BGA TECHNICAL COMMITTEE

TECHNICAL NEWSHEET (TNS) 5/6/95

Potential Control System Foul

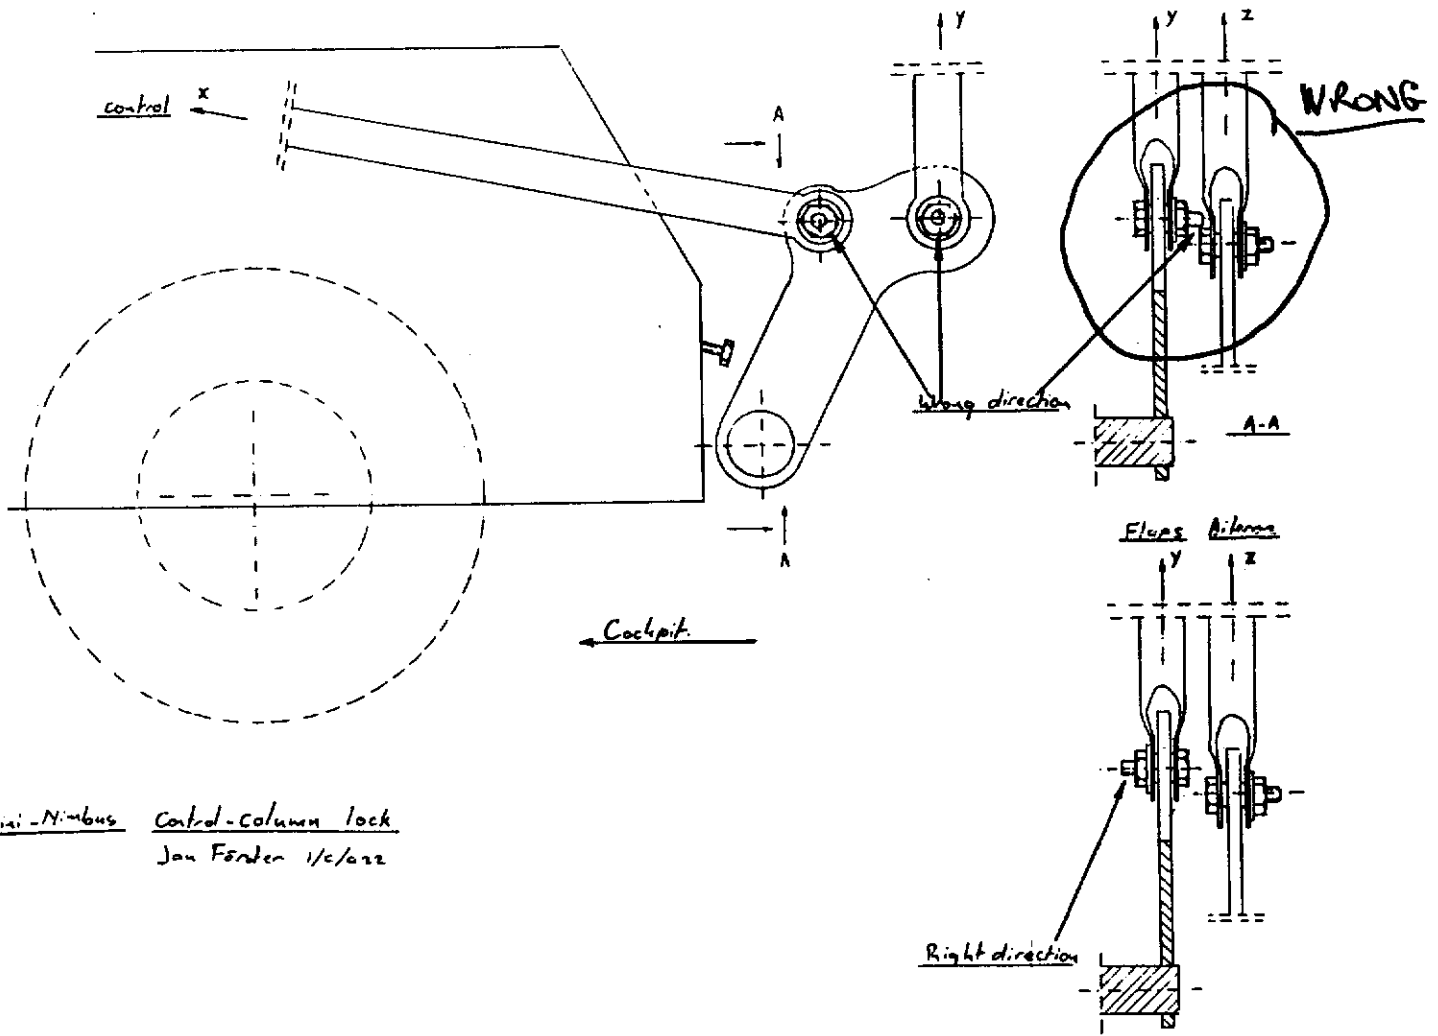
- PART 1 AIRWORTHINESS "AGGRO" - Please add to the BGA's 1995 Blue Pages.
- 1.1. MINI-NIMBUS - Potential control system foul is illustrated in attached sketch. (Jan Forster).

Mini-Nimbus Control-Column lock
 Jan Fender 1/6/22

Already Actioned By SB. 306-33 (1994)

Ka6 - ROT AT BASE OF FIN.

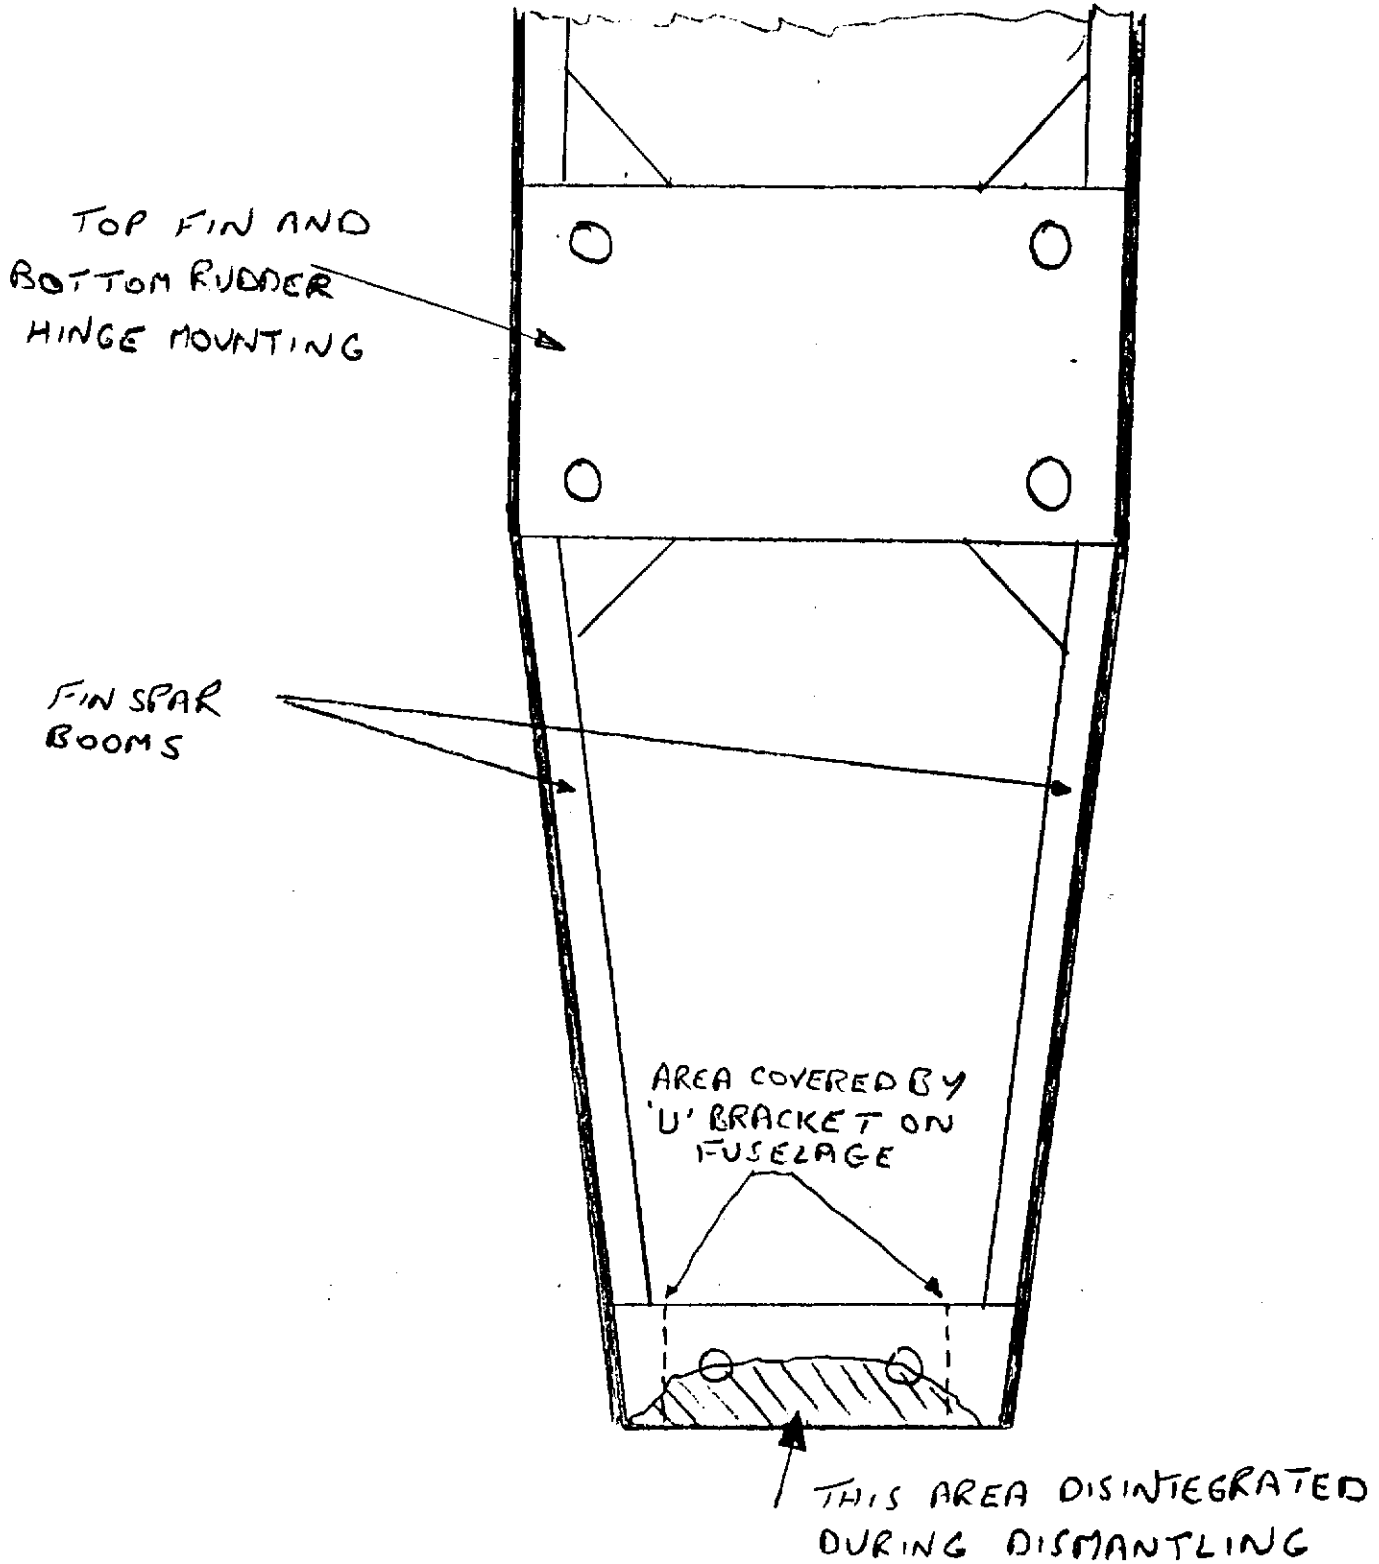
- 1.5. OLY 460 Winch Launched with one Tailplane not secured - landed safely! (Portmoak).
- 1.6. KA6 (Series) Rotten Structure - below the paint at base of the fin. Sketch from R.W. Collins. Has been reported previously on KA7/13 etc. Look carefully by removing the paint!

K6B BGA 1458 VIEW ON REAR OF FIN

L'Hotelier Connection Alternative Locking Arrangement (Non-Wedge Type)

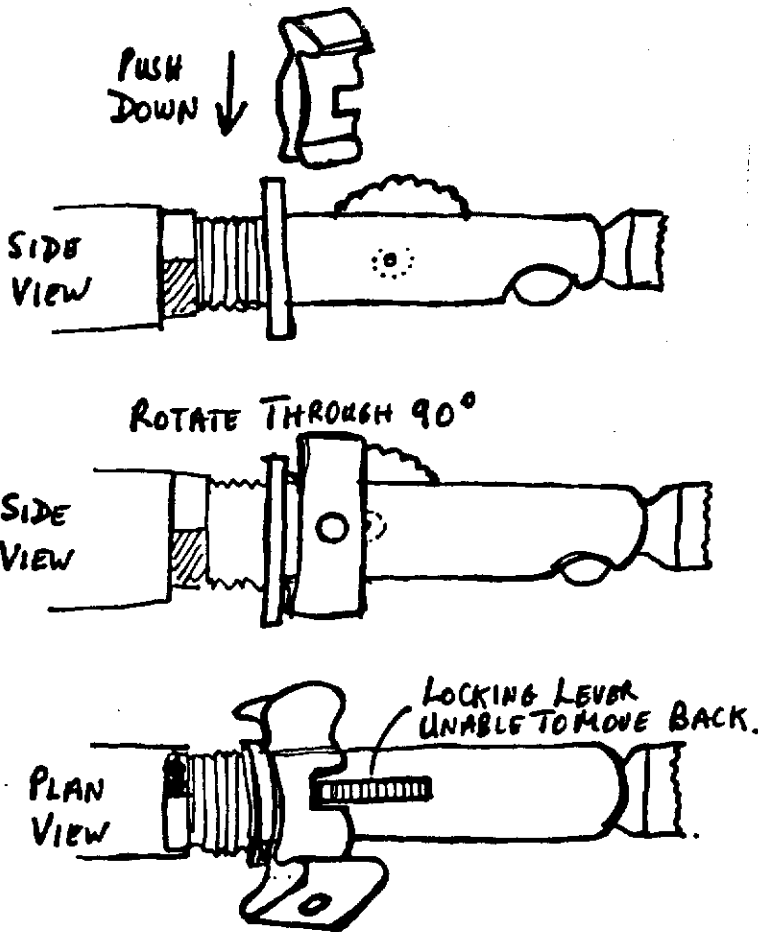
Connecting L'Hotelier on Standard Cirrus (and other types) is tricky since one is working blind, through a trap door, and over the main spar. Inserting "R" pins is well nigh impossible.

Adapted "Terry" tool clips make the job possible. The adaption is to file a slot as shown. The "Terry" clip is tethered via nylon cord to hollow rivet holes already present in the ends of the push rods.

Having made the connection, the "Terry" clip is pushed vertically down over the locking lever and then rotated through 90 degrees at which time the clip "clicks" into position over the lever. The depth of the groove is not critical, since even if the remaining body of the clip does not clear the lever, the serrations in the lever prevent any backward movement of the same. Removal is achieved by pushing the "Terry" clip forward.

GROOVE FILED
3/4 WAY UP
"TERRY" TOOL CLIP

Einbauanleitung "Versteifung für Seitenflosse"

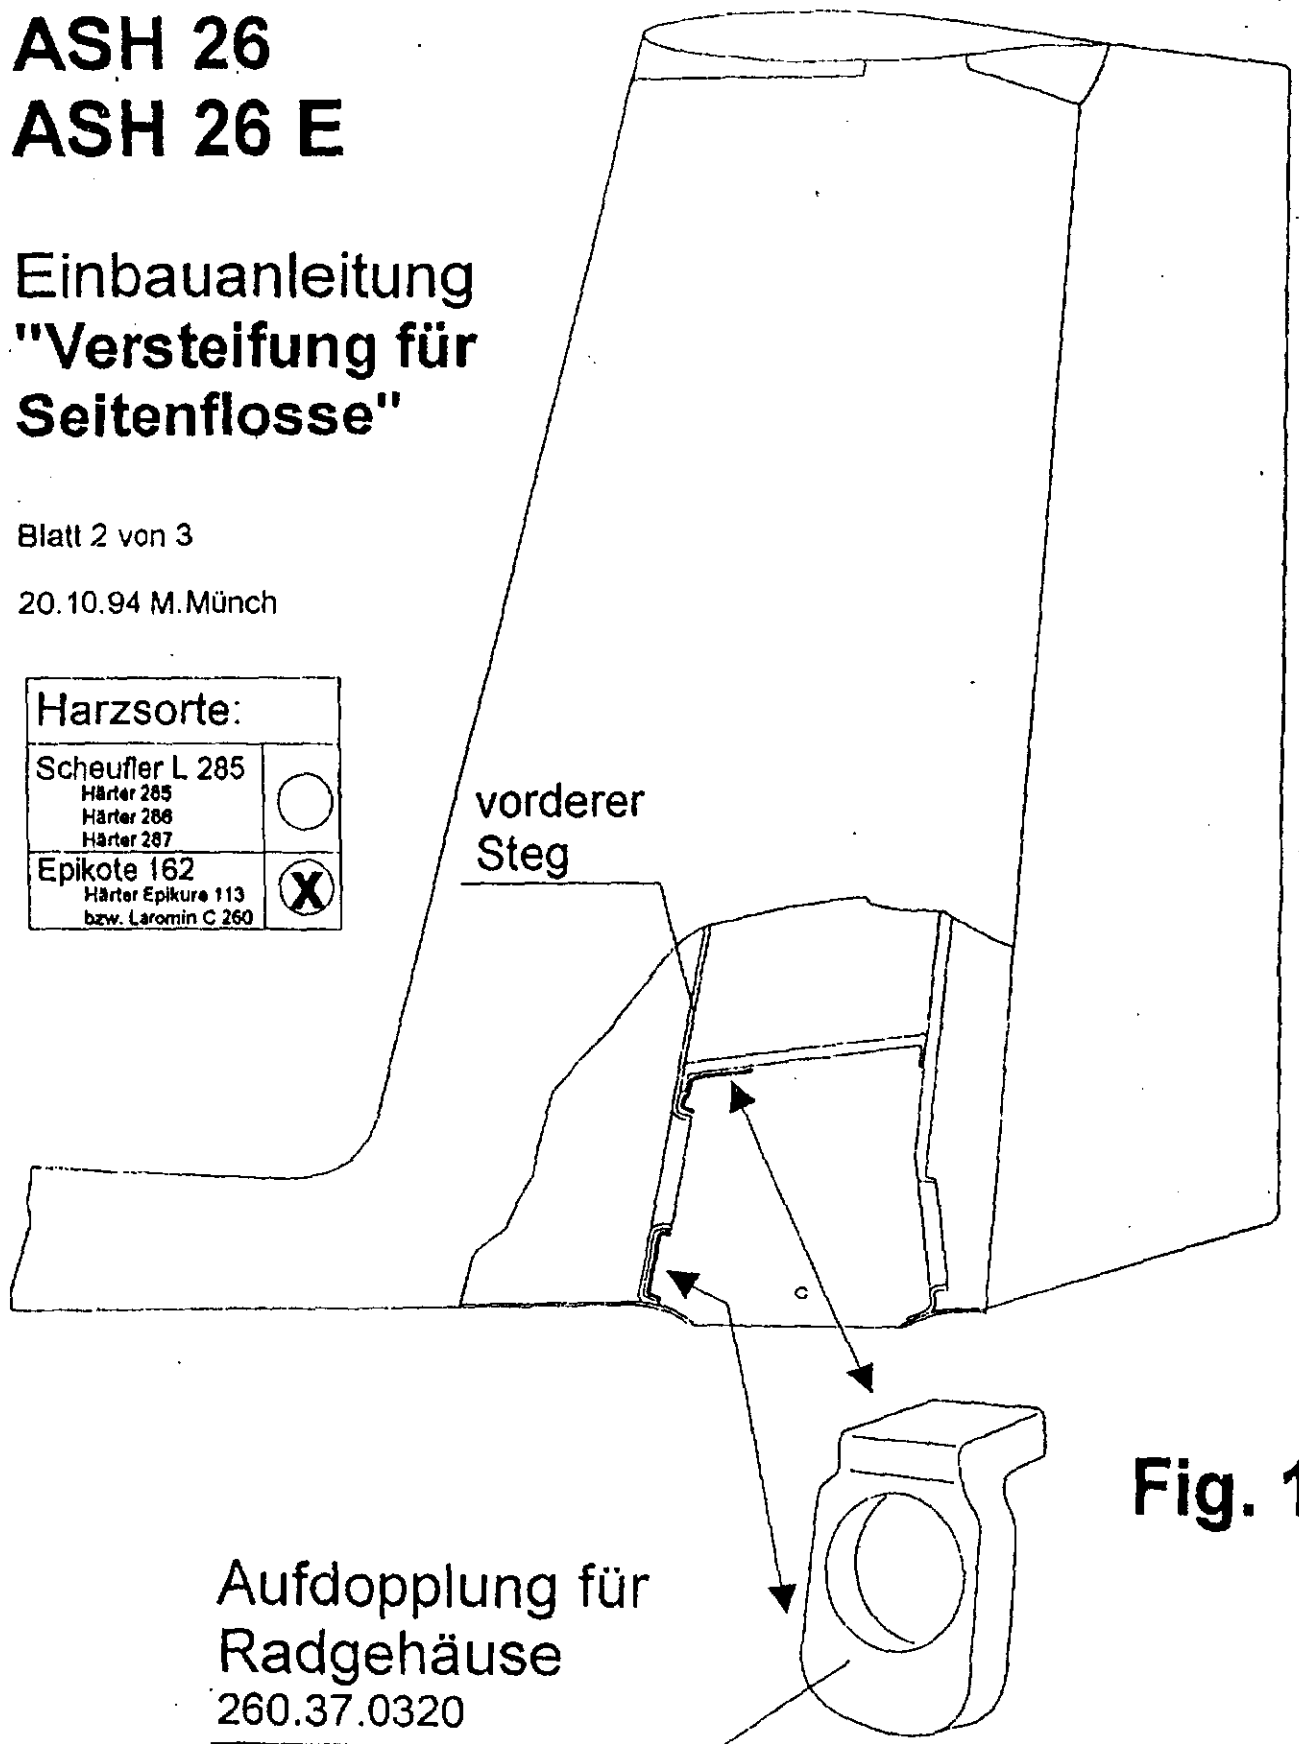
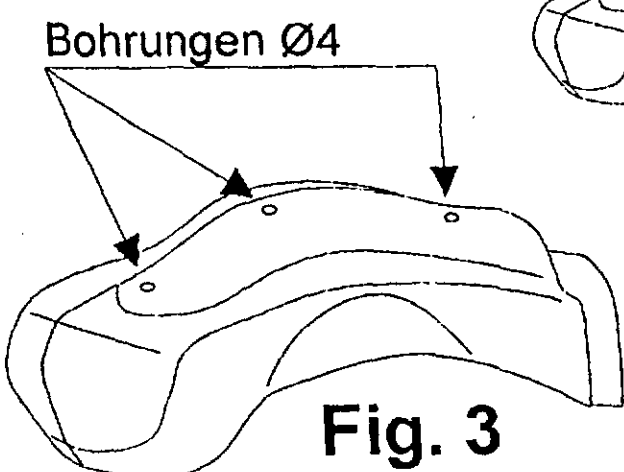
- 1.12. STEMME S10 - V - LBA A/D 95-177 concerns propeller blade extension fork.
- 1.13. ASH 26/26E - Rear fuselage modification as required - ref attached sketches.
- 1.14. Centrair 201. A/D 95-0085(A) requires inspection of Elevator Control.
